ADDENDUM # 1

November 5, 2021

**Bataan Lift Station Renovation
Bid No. 2021-09**

Bohannon Huston Inc.

BHI PROJECT NO.	20210255	DWG NO.	E-700-R1	SHEET OF	28	29
-----------------	----------	---------	----------	----------	----	----

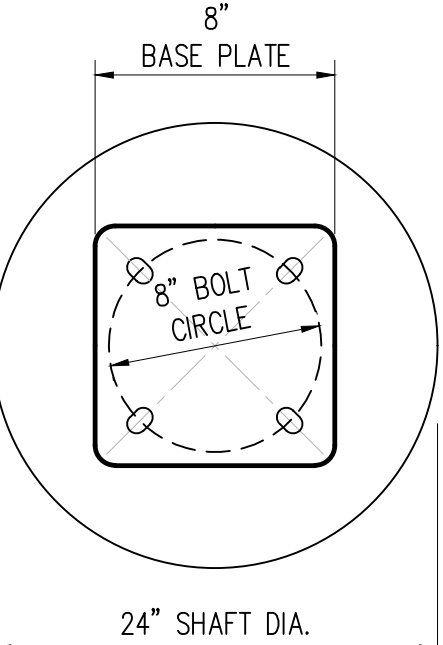
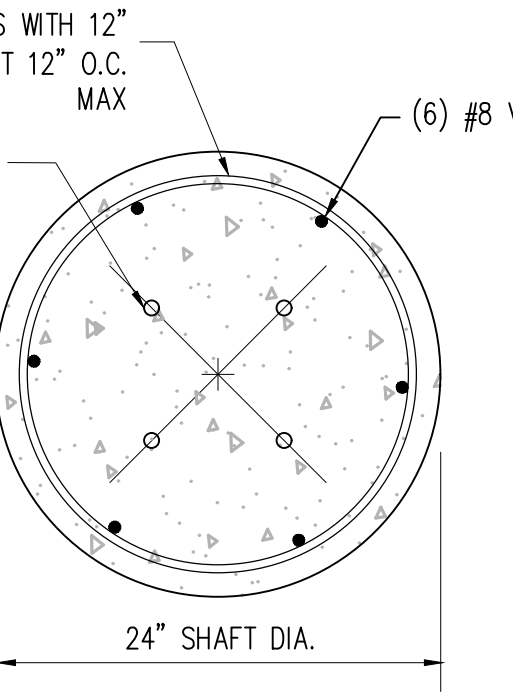
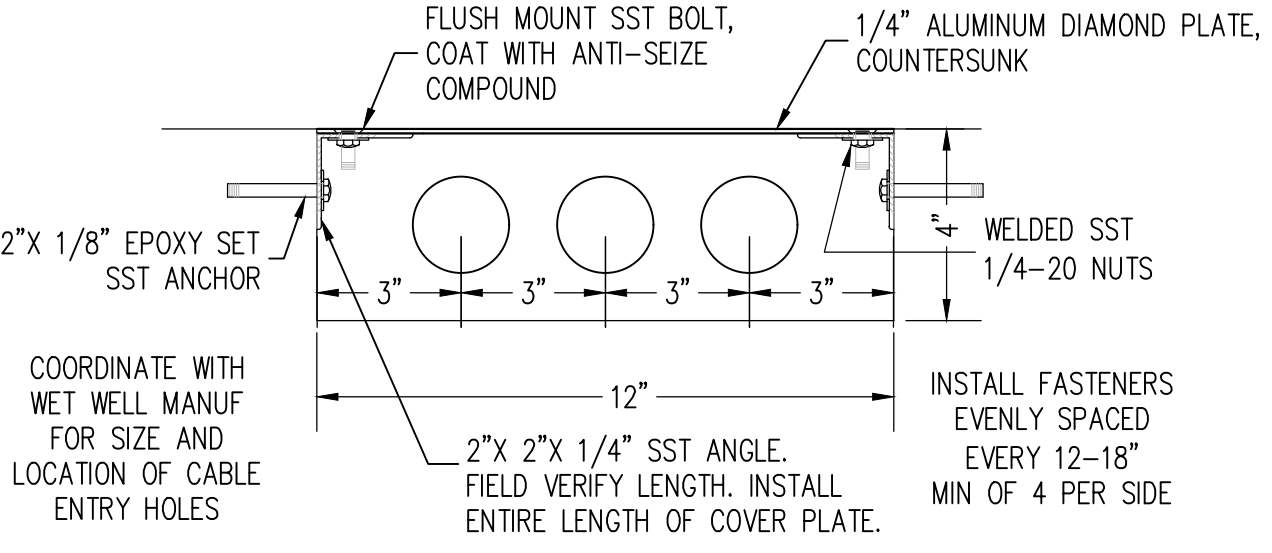
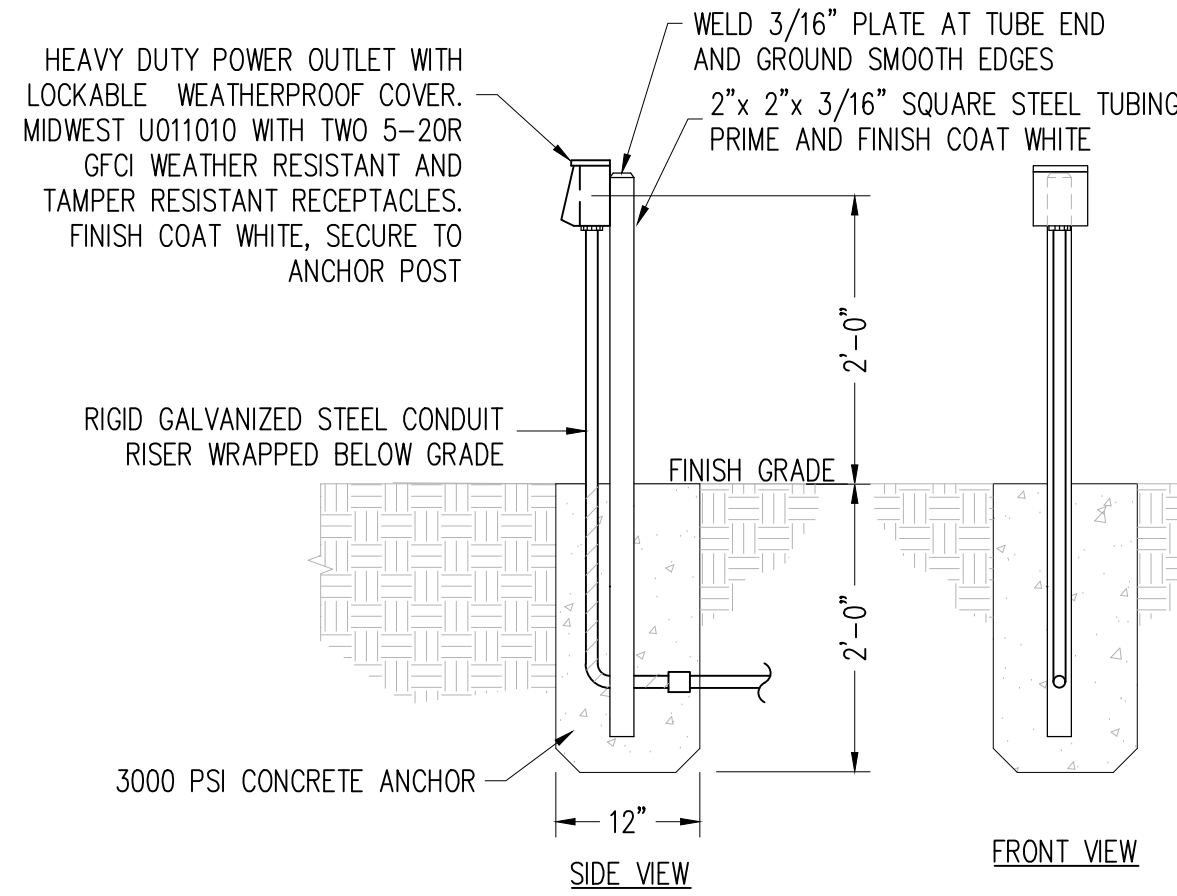
8. **Drawing E-700-R1**: Revised equipment rack detail to lengthen depth of shade structure; Deleted submersible cable junction box details; Reordered details.
